Determination 2011/008

Refusal to issue a code compliance certificate for a 9-year-old house with macrocarpa posts and beams at 16 Oak Tree Lane, Rolleston

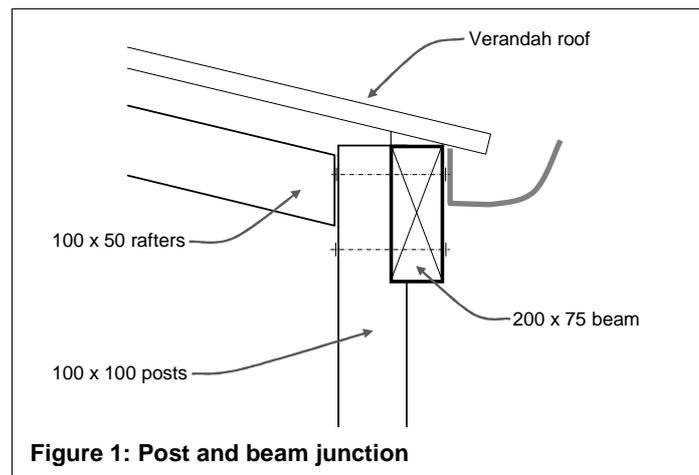
2.3.3 The posts are rebated and bolted to the inside of the verandah support beams, with rafters fixed to posts and beams as shown in the following sketch:

- The tiled shower was required to comply with Clause B2 in addition to E3. The authority did not believe reasonable ground existed for it to be satisfied that the shower membrane was code compliant.
- The possible damage to the corner framing was raised 'for greater clarification to support the refusal [to issue] the code compliance certificates in regards to the durability provisions of the Building Code' and was part of the authority's 'peer reviewing code compliance certificates prior to issue'.
- The PIM noted the building was in a high wind zone.
- Figure 1 was not fully representative of the as-built work.
